SWAY BAR CLAMP HARDWARE REPLACEMENT

Prevost vehicles

On the vehicles affected by this bulletin, replace the hardware on the sway bar clamps of the steer and drive axles.

Figure 1

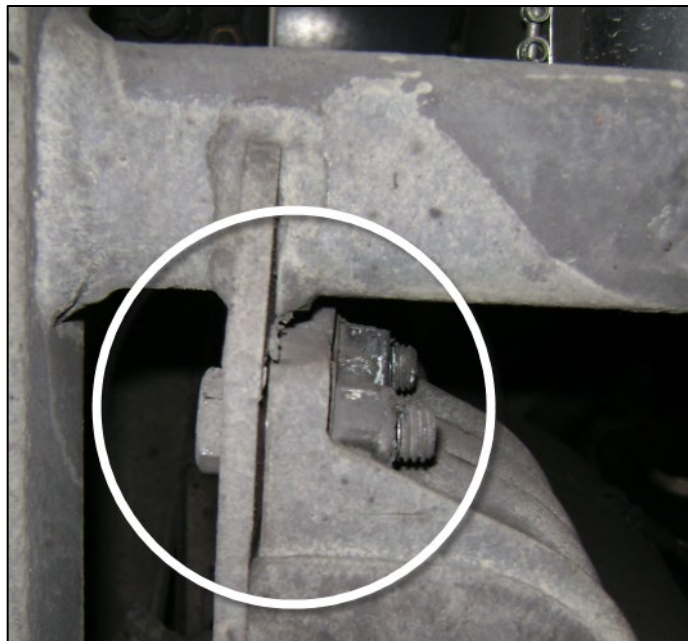
1. On the front steer axle and on the rear drive axle, clean the sway bar clamps around the upper bolts.
2. Perform a thorough visual inspection of the contact surface between each sway bar clamp and the frame support.

Make sure that there is no welding or gravel guard accumulation interfering with the contact surface. (the surface between the clamp base and structure) (Fig. 1)

Figure 2

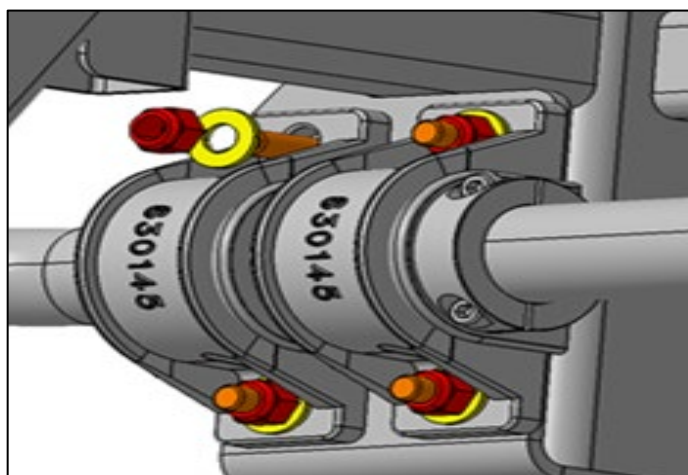
Remove and discard old hardware and replace with new bolts, nuts and washers one at a time. (fig. 2)

Confirm proper washer orientation before tightening. See fig. 3.

*All surfaces in contact with washer must be **clean and dry**.*

Tightening must be done two times (lower bolt , upper bolt, lower bolt , upper bolt)

Torque to **90lbf-ft**

Apply Valvoline corrosion protection on hardware after tightening.
